Bramford to Twinstead Tee Connection Project

Western cable sealing end compound

Proposed siting

November 2012

Project: Bramford to Twinstead Tee Connection		
Title: Preferred Underground Cable Route and CSE Compound Location in Western part of Study Area G		
Drawing No: G1980.925		
Date: 20-11-2012	TEP Ref No: G1980.925	
Drawn: CB	Checked: CH	Approved: CH

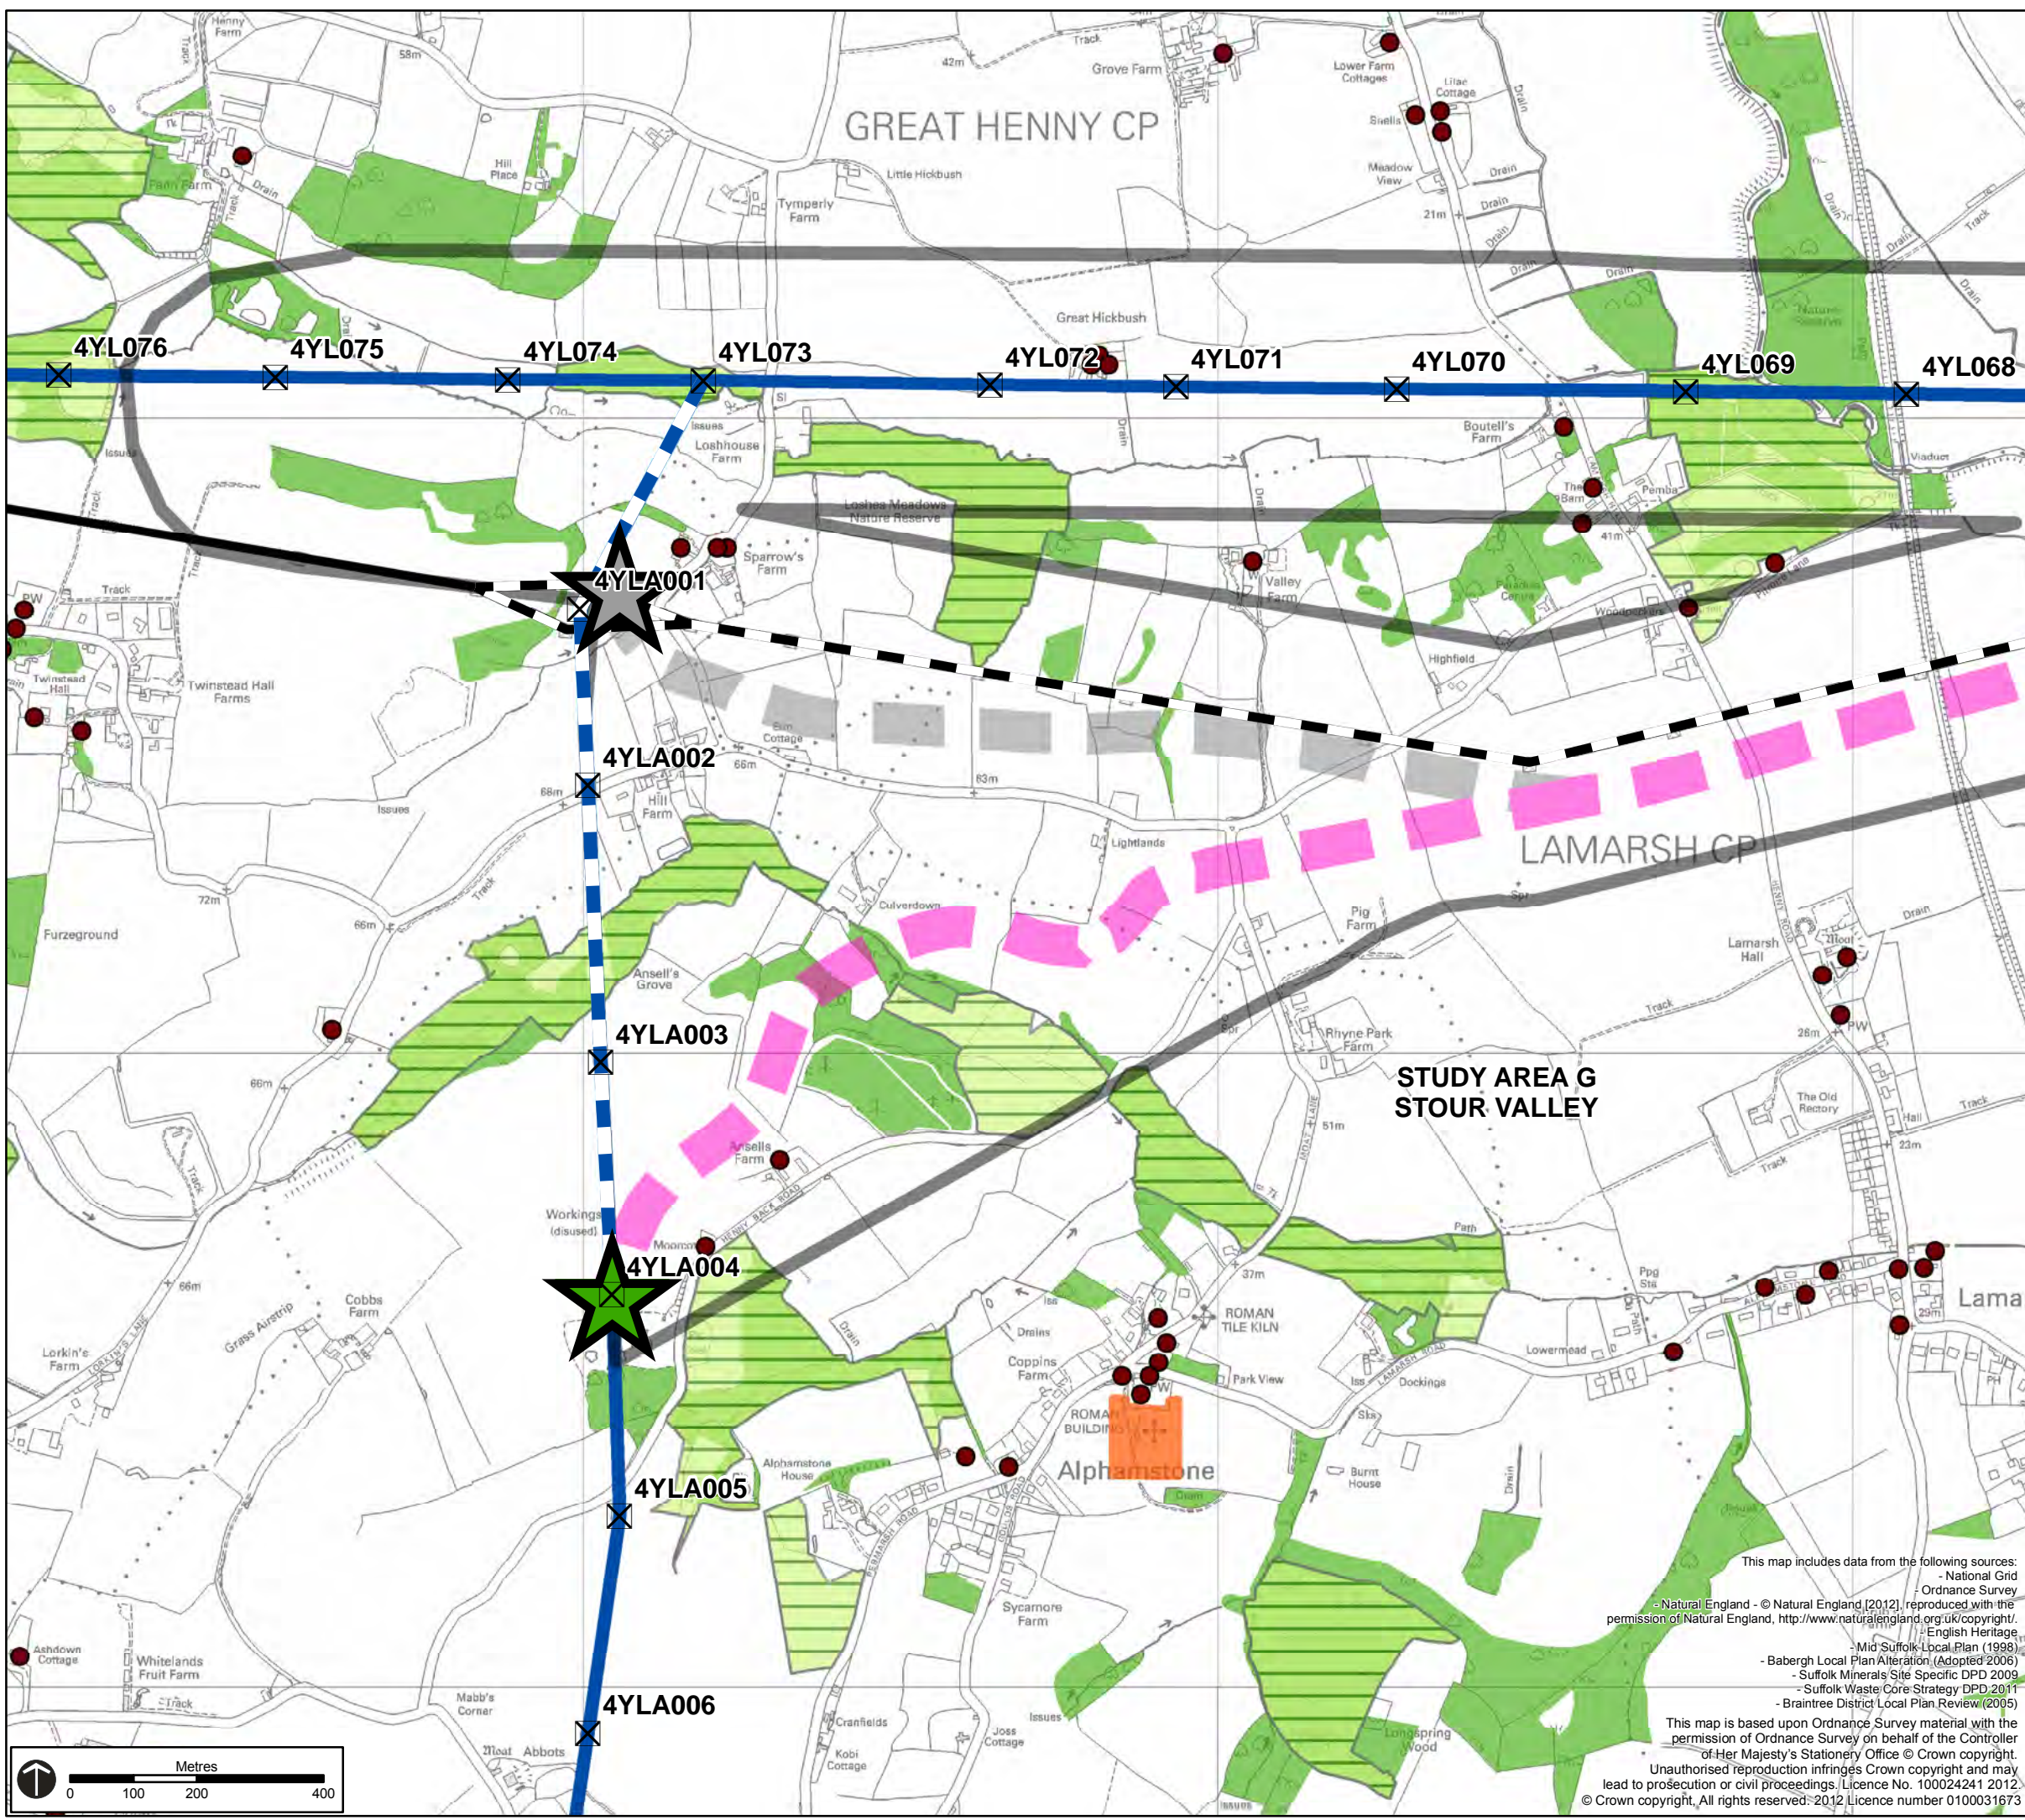
- 3.3 Braintree District Council⁴ also considered that there was a need to set out the detailed alignment of the underground cable taking into account environmental and engineering constraints. It did not support the location of a CSE compound in the vicinity of 4YLA001 because of its effect on the Stour River Valley landscape and impact on public views from protected lanes, public rights of way, Loshes Meadow nature reserve and Sparrows Farm and access off a Protected Lane. It wished to promote a site 1.5km further south near pylon 4YLA005.

- the underground cable should bear south to connect to the existing line at a less sensitive point at least as far south as pylon 4YLA004. The special landscape characteristics justify the CSE compound being located well south of Ansell’s Grove;
- a preference for a CSE compound site south of Henny Back Road at pylon 4YLA005, thus removing 400kV pylons as well as the 132 kV diamond crossing from the Special Landscape Area;

3.8 It was queried whether positioning a CSE compound in the bottom of the valley in the vicinity of pylon 4YLA001 would mean that the height and volume of the CSE compound structure would be much greater than would be the case if it were sited at or between pylons 4YLA004 and 4YLA005.

- 4.8 On balance it was considered that there would be benefits in siting a CSE compound in the vicinity of 4YLA004 and that a route for an underground cable could be developed to connect this location to the connection across the Stour Valley to the east. As with the siting of CSE compounds elsewhere on the project, further studies will need to be undertaken to establish the most appropriate site for the compound in this general location.

- 5.1 Subject to consultation with affected parties, the interim alignment at the western end of Study Area G is to be amended to include an underground cable connection with a CSE compound in the vicinity of pylon 4YLA004 to effect a connection to the Twinstead Tee - Braintree 400kV overhead line. Selective use of directional drilling would enable initial concerns about the effects of such a cable route on local habitats to be allayed. The benefits of this arrangement are that, in addition to the removal of the 132kV overhead line east of the Twinstead Tee - Braintree 400kV overhead line, it would result in the removal of a section of the latter line between the connection point and Twinstead Tee. Both of these modifications would result in an enhancement of the environment in the vicinity of Sparrow's Farm and Hill Farm. Those adverse effects identified in representations would be avoided.
